HISTORIC AND DESIGN REVIEW COMMISSION

HDRC CASE NO: 2018-328
ADDRESS: 230 ADAMS ST
LEGAL DESCRIPTION: NCB 943 BLK 1 LOT SW 100 FT OF 16
ZONING: RM-4 CD, H
CITY COUNCIL DIST.: 1
DISTRICT: King William Historic District
APPLICANT: Genevie Ramirez/Build Modern
OWNER: David Roberson/Build Modern
TYPE OF WORK: Exterior modifications, window replacement, porch modifications, construction of a rear addition and fencing
APPLICATION RECEIVED: June 29, 2018
60-DAY REVIEW: August 28, 2018
REQUEST:

The applicant is requesting a Certificate of Appropriateness for approval to:

Re: Adams Rehab – Project Narrative

A2.01

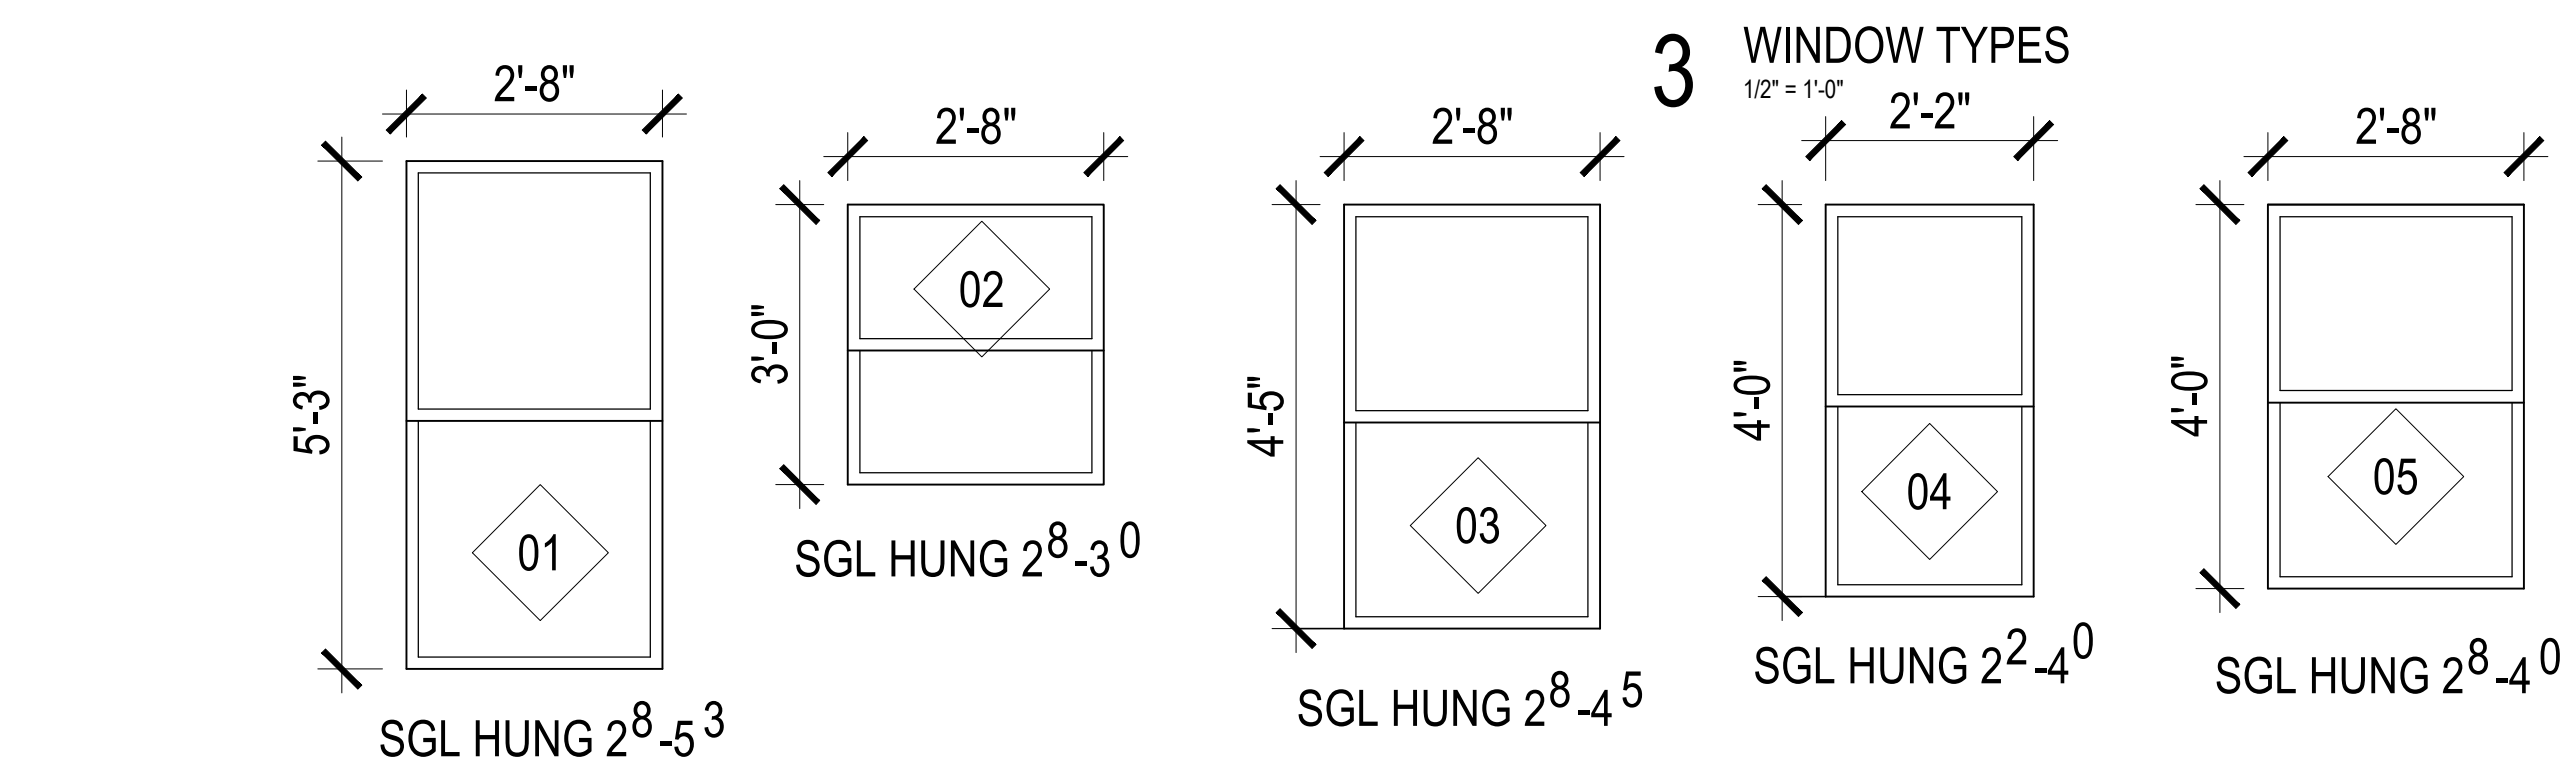
- d. **FENCING** – The applicant has proposed to install an aluminum fence to feature four (4) feet in height to be located parallel to the property line on both the Adams and Stieren sides of the property. The applicant has proposed a sidewalk gate and has proposed for the fence to stop at the driveway on Stieren. Staff finds the proposed fence on this block of Adams to be appropriate. The proposed fence should align with those featured on neighboring properties.

We are proposing to install a new black metal 4'-0" fence at the south and west elevation. Please see sheet A2.01 that has notes indicating the location and length of the fence.

3. Staff recommends approval of item #3, the installation of a front and side yard fence based on finding d with the following stipulation:
 - i. That the proposed fence not exceed four (4) feet in height and that it align with neighboring fences.

W PROPOSED EXTERIOR ELEVATION
3/16" = 1'-0"

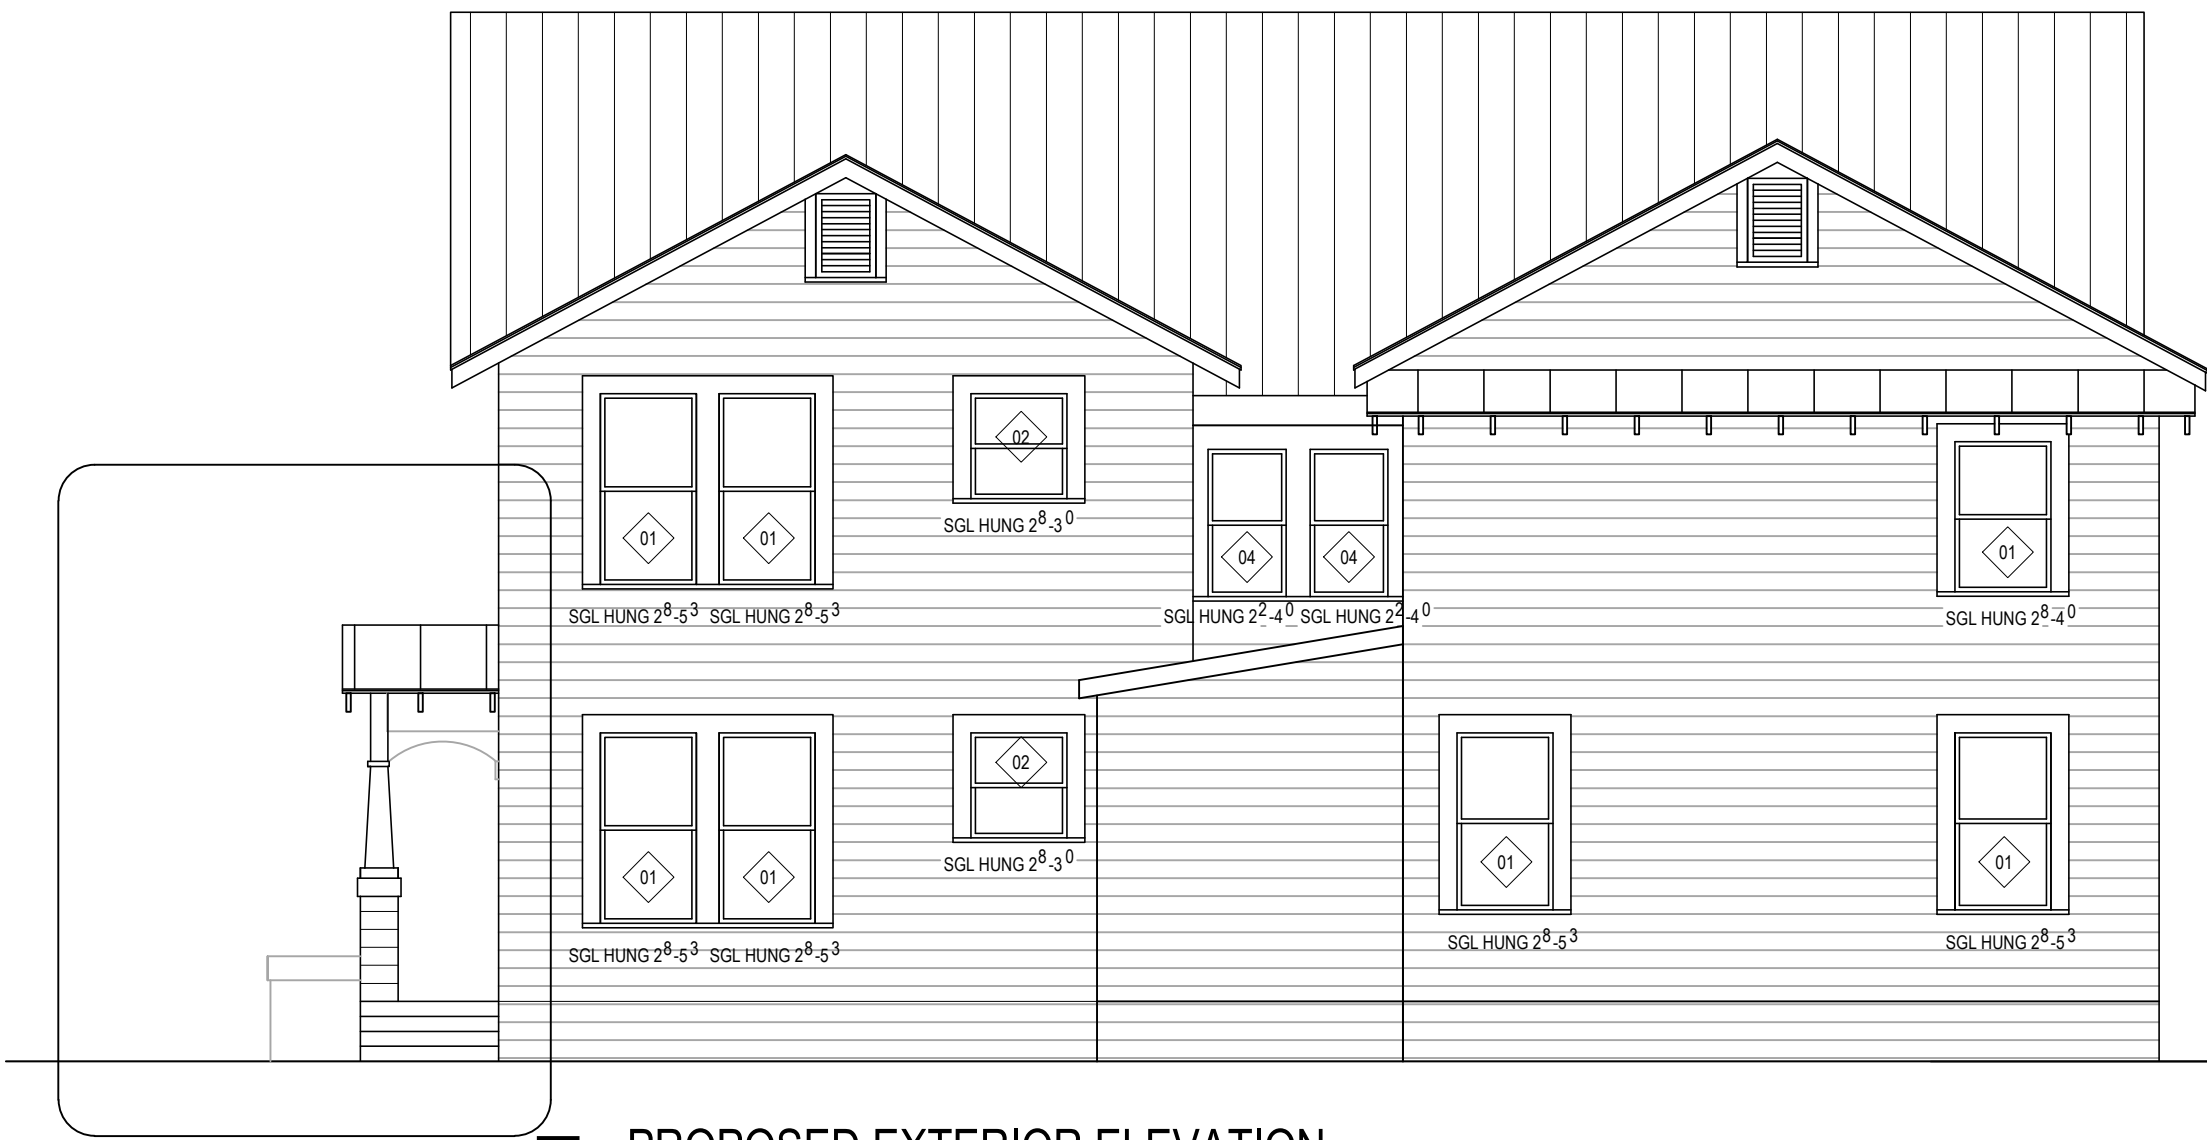
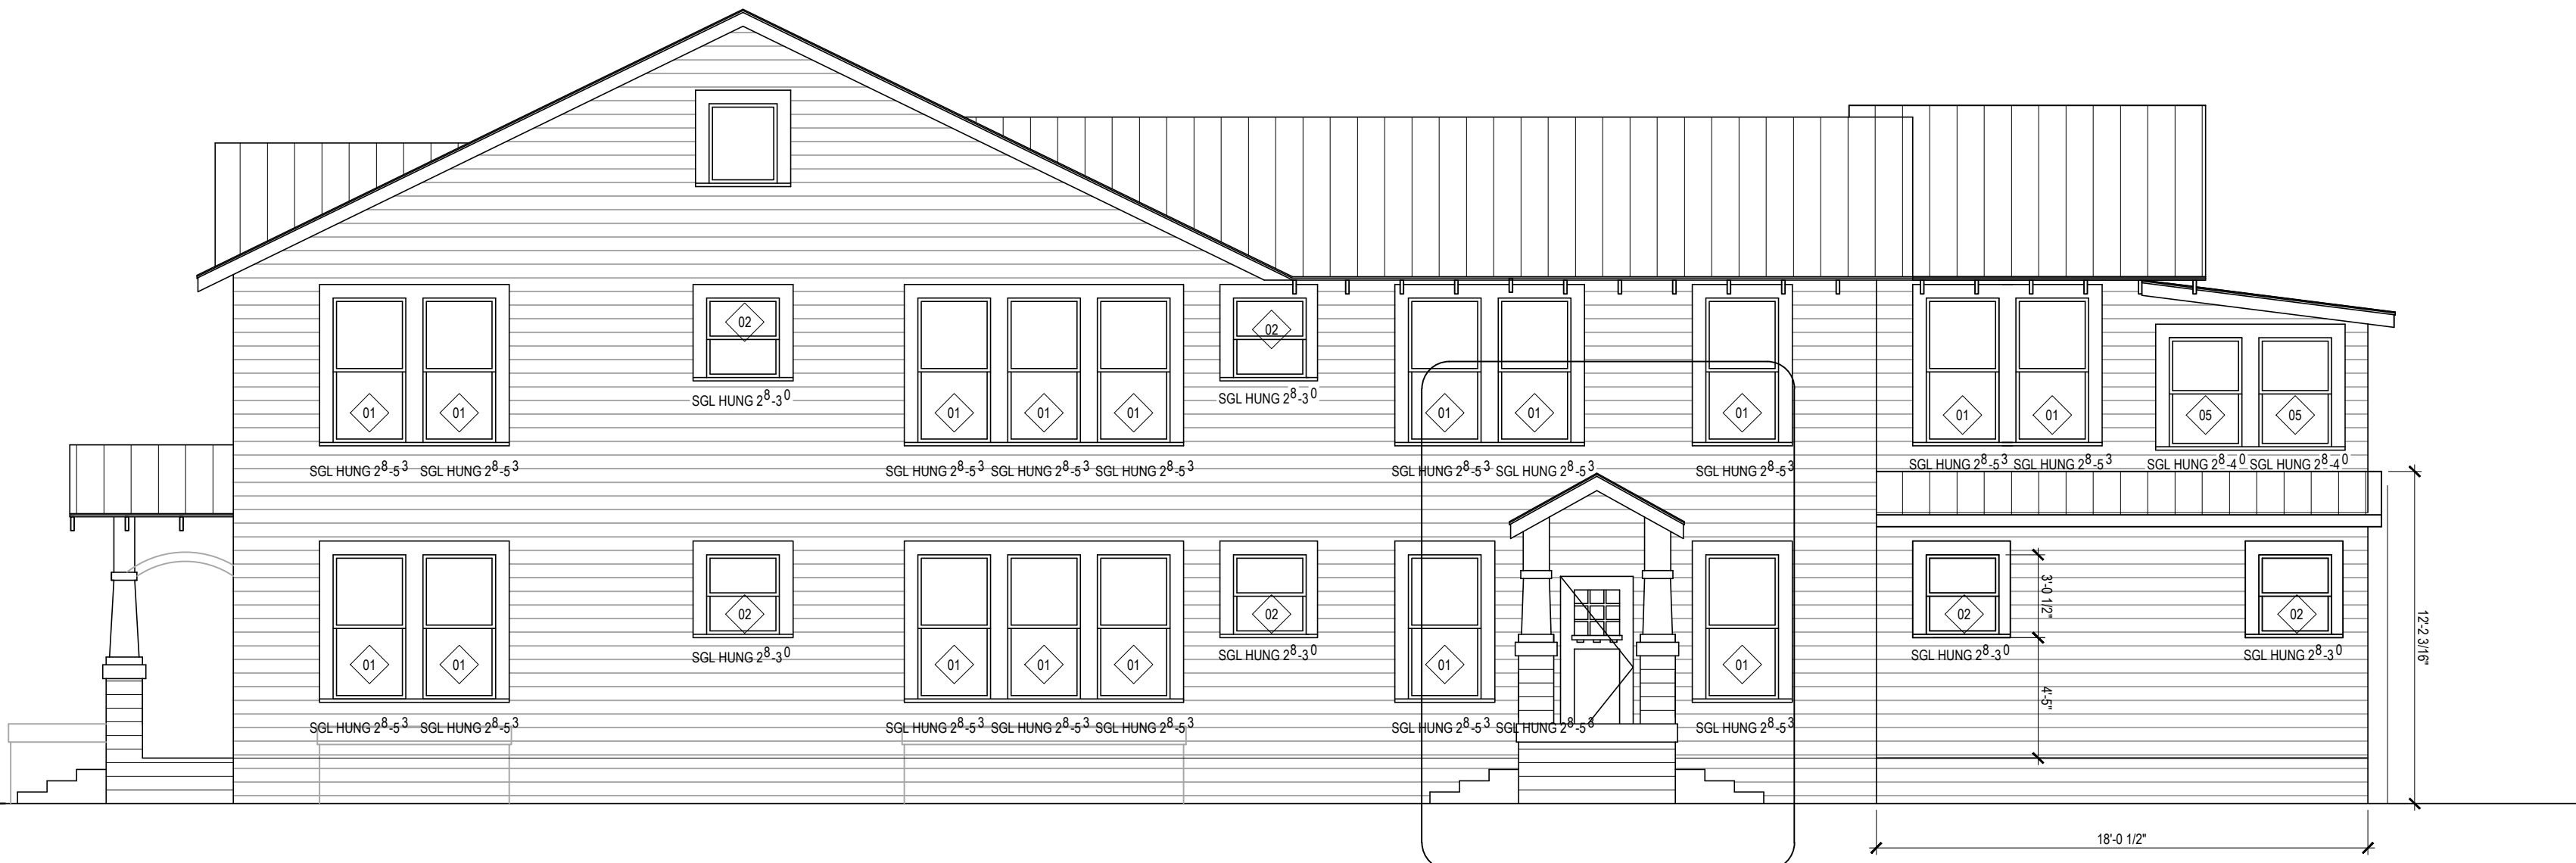
- e. **REAR ADDITION** – At the rear of the historic structure, the applicant has proposed construct an addition to replace an existing, rear porch., The applicant has proposed for the addition to feature a shed roof to match that of the existing porch roof, two, one over one wood windows and wood siding. Staff finds the proposed addition to be appropriate; however, the siding material should be stucco to match that of the existing structure, per finding b.

- g. **PORCH MODIFICATIONS** – The applicant has proposed to modify the existing porches and porch roofs by removing the existing plaster and stucco facades, columns and column pediments and installing brick pediments as well as opening the existing porch walls. Per the Guidelines, porches should be preserved as they exist. Reconstruction and modifications should only be performed if based on evidence of a previous design. Staff finds that the installation of new cedar columns and the proposed modifications including the removing of both roof and sidewall structure are inconsistent with the Guidelines.

4. Staff recommends approval of item #4, the construction of a rear addition with the following stipulations:
 - i. That the proposed façade material be stucco to match as close to that of the historic structure as possible.

- ii. That the proposed windows feature a depth that matches those found in the historic structure.
5. Staff recommends partial approval of item #5, window replacement, only where windows are non-repairable as noted by staff in the exhibits. Staff does not recommend approval of wholesale window replacement. The applicant may present additional information to staff regarding the replacement of windows that are deteriorated beyond repair that were not accessible to staff during the site visit.

6. Staff does not recommend approval of item #6, porch modifications, based on finding g.

3 PORCH ELEVATION
1/4" = 1'-0"

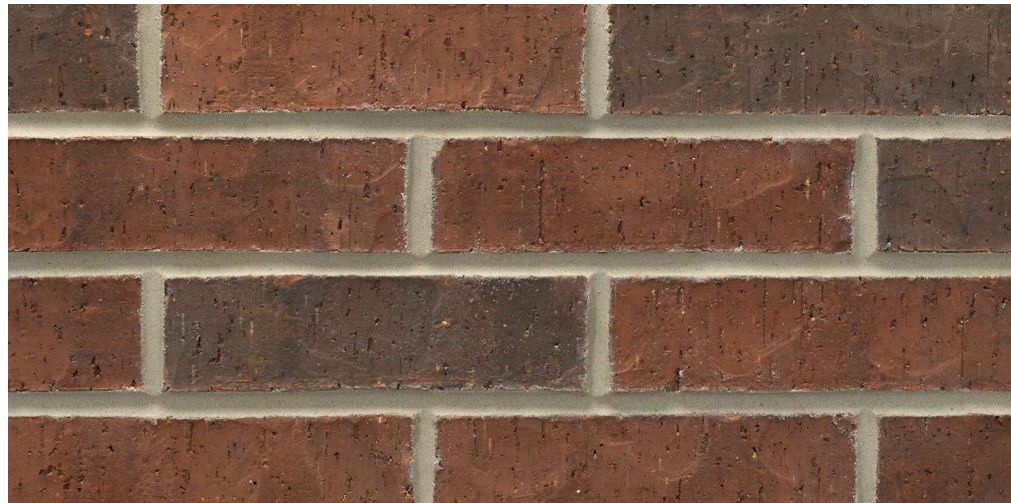
We are proposing to open up the existing porches on the south and west elevation by removing the existing stucco material. We are also proposing to add a brick base to the columns and exposing a new cedar post at the top portion of the columns. Please see sheet A4.02 that shows a colored image as well as exterior elevations. All dimensions will remain the same.
